# DETAILED CONSERVATION COMMISSION AGENDA

Date: Thursday, December 9, 2021

**1. (7:00) 100 Boulder Road – NOI (cont'd) – addition, deck, patio to a single-family home – DEP file #239-908**

44 BRANDEIS ROAD  
PROPOSED ADDITIONS

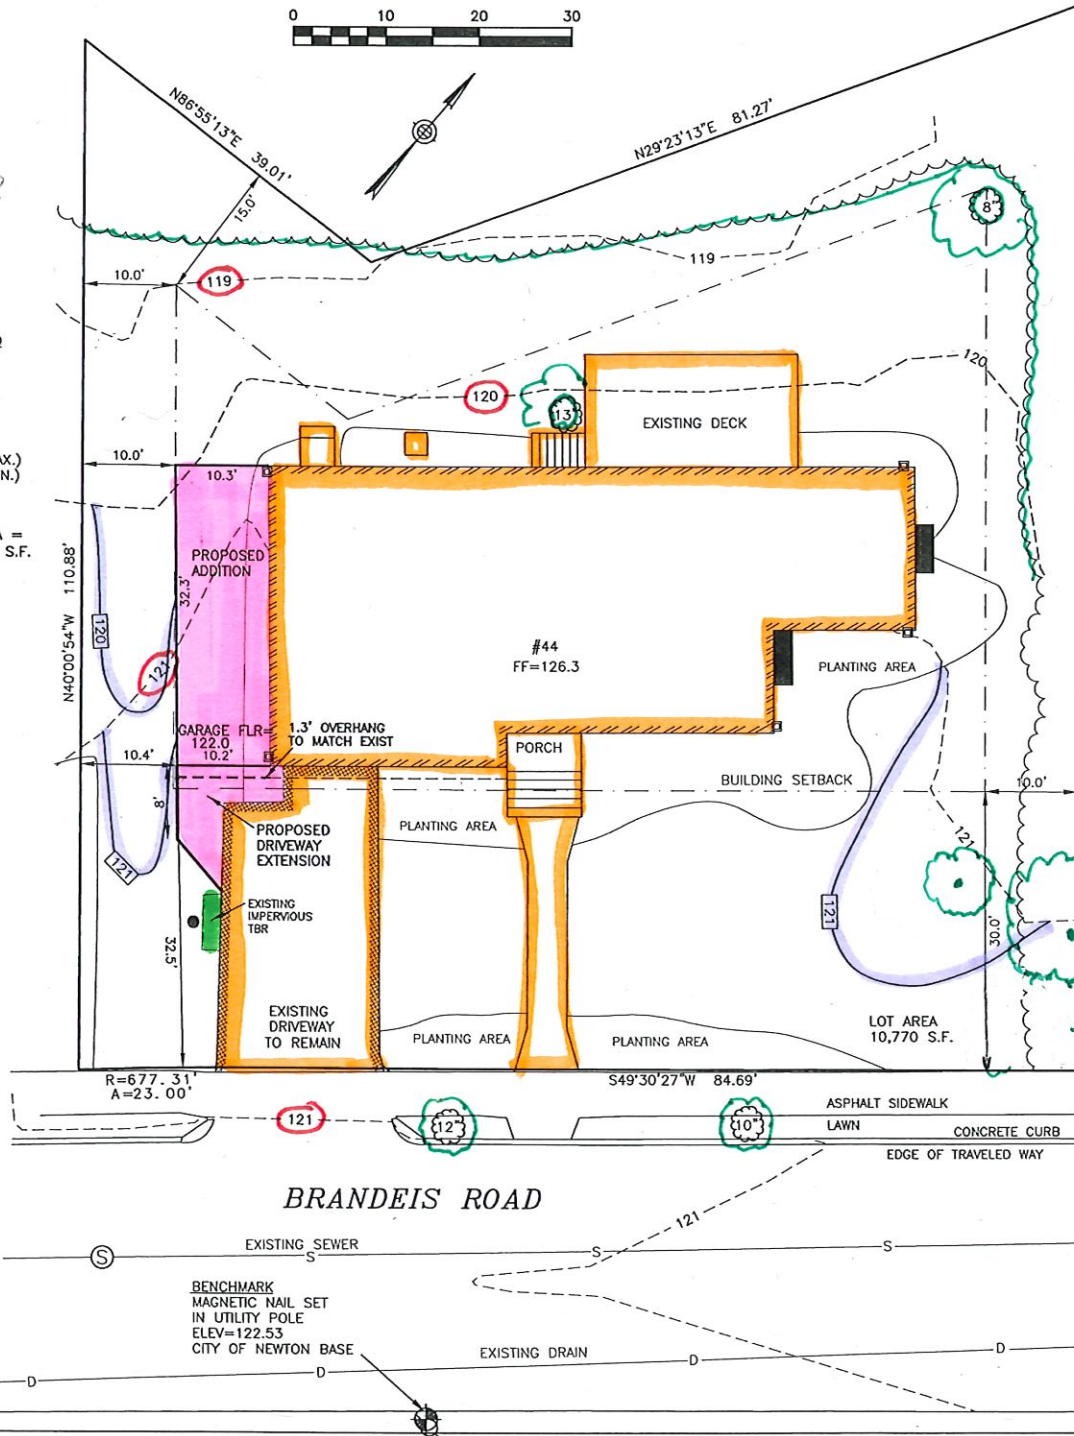
- The proposed grading in the front yard will disturb an existing mature shrub and the roots of a mid-sized tree.
- The cut and fill table shows a cut from 121-122', but there is not a corresponding grade change line on the plan. Cut and fill calcs and or site grading should be revised to ensure accuracy.
- Staff Recommendations: Once above issues are addressed and revised plans have been submitted as appropriate, vote to close the hearing and issue an Order of Conditions with the following special conditions.
  - The addition shall be slab-on-grade construction; there will not be a basement below the addition.
  - Compensatory flood storage must be provided in its entirety as per the grading shown on the approved plans.

FROM WHERE?

SHEET C4

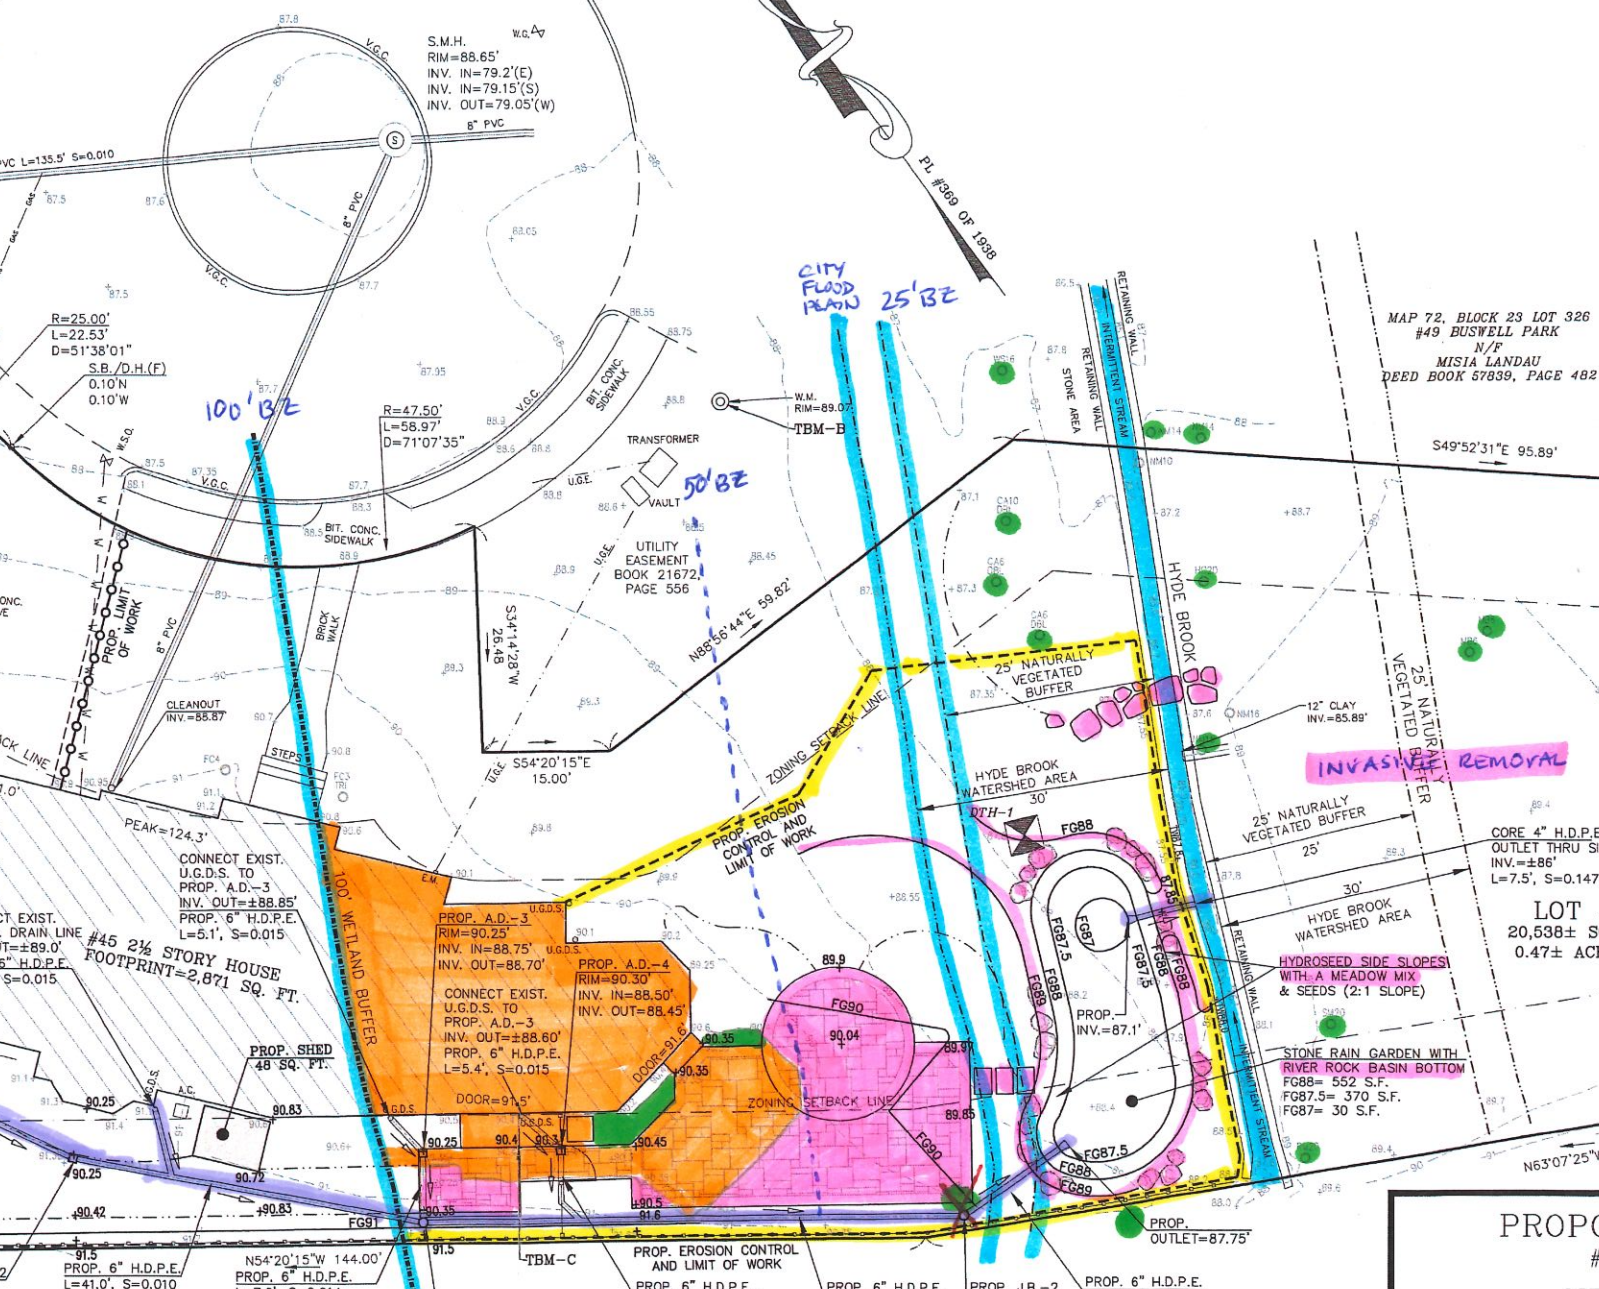
- There is no laydown or stockpiling area identified on the plan. This should be addressed.
  - Some fill associated with the grading for the patio is within the City Flood Plain and appears to be at elevation 89-90'. The cuts associated with the rain garden appear to be at 87-88' and 88-89'. The City Flood Plain Ordinance requires foot-for-foot compensation of fill in the City Flood Plain ("Compensatory storage shall mean a volume not previously used for flood storage, and shall be incrementally equal to the theoretical volume of flood water at each elevation which would be displaced by the proposed project."). The discrepancy should be rectified.

- The applicant should submit the written approval from Newton DPW for the proposed coring into the wall of Hyde Brook for the overflow drain pipe.
  - The number of plants shown on the plan within the Buffer Zone do not appear to comport with the numbers shown in the planting schedule. The plans should be vetted and any discrepancy rectified.

- There are 44 shrubs proposed in the Buffer Zone, but no shrubs proposed along the stream. All the shrub plantings appear to be for screening, not ecosystem enhancement. The planting plan should likely be revised.

- There is a small tree that will be removed for the installation of the patio. This should be noted on the plan and potentially accounted for/reflected in the mitigation planting plan.

- The roots of one large tree just off the property may be adversely affected by the grading/excavation for the proposed rain garden. This should be addressed.

<b>22 Hollywood Drive</b>	
<b>Newton, Massachusetts</b>	
<b>Enforcement Order Response Plan</b>	
Scale: 1"=20'	July 16, 2019
<b>VERNE T. PORTER Jr., PLS</b>	
Land Surveyors - Civil Engineers	
354 Elliot Street Newton, Massachusetts 02464

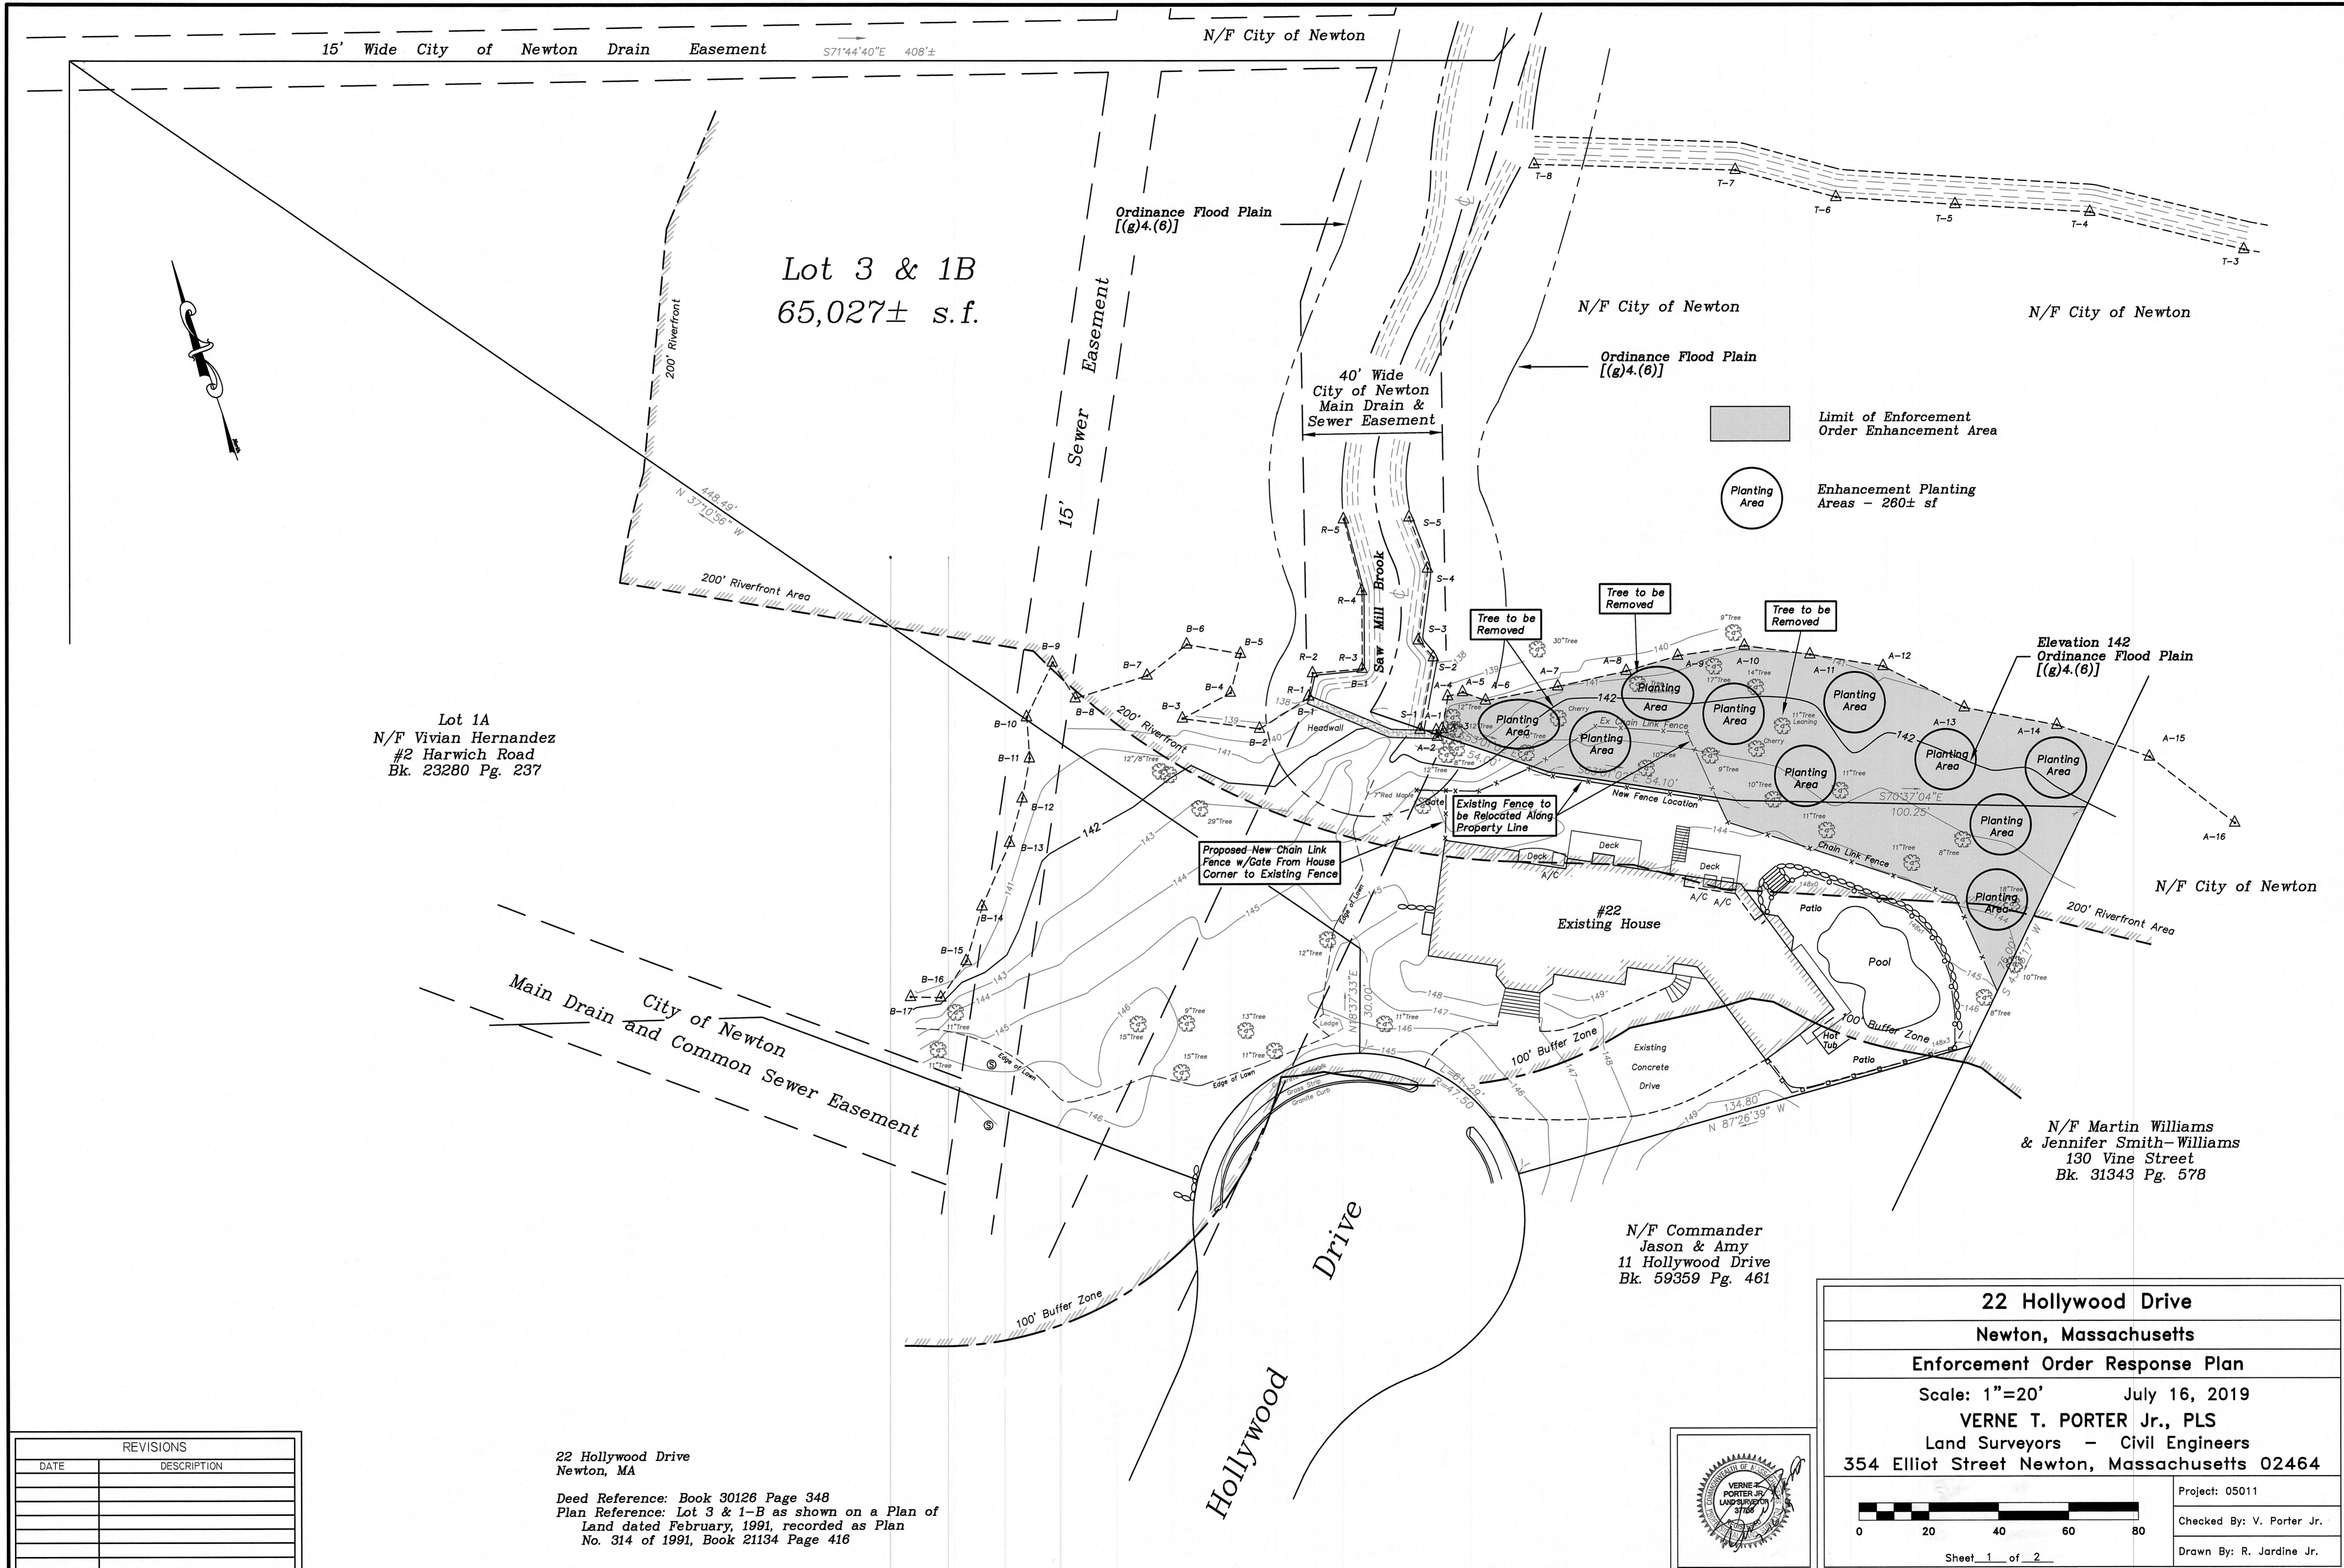
- Staff applaud the efforts of the owners to remove invasives and install natives.
  - 96 shrubs (60%) were observed to be alive in Nov. 2021. Staff believe that a few more shrubs should be installed along the lawn-restoration area line, with photographic proof of proper installation, but with no long-term survival requirements.

- Staff noted a tree stump but have no record of a permit for the removal of that tree. Commissioners should discuss whether a replacement sapling would be appropriate.

- To facilitate tree removal and pruning, the chain-link fence was entirely removed from the site, however staff feel that given the openness of the site, a fence (e.g., split rail) is necessary to define the extent of “lawn” and the edge of the restoration area should still be required.

11/23/21 site visit:

- No fence in place
- No understory near "line"
- No deed restriction
- Trees cut (circled)
  - ⊗ - ailing - per old photos
  - - ? - per old photos
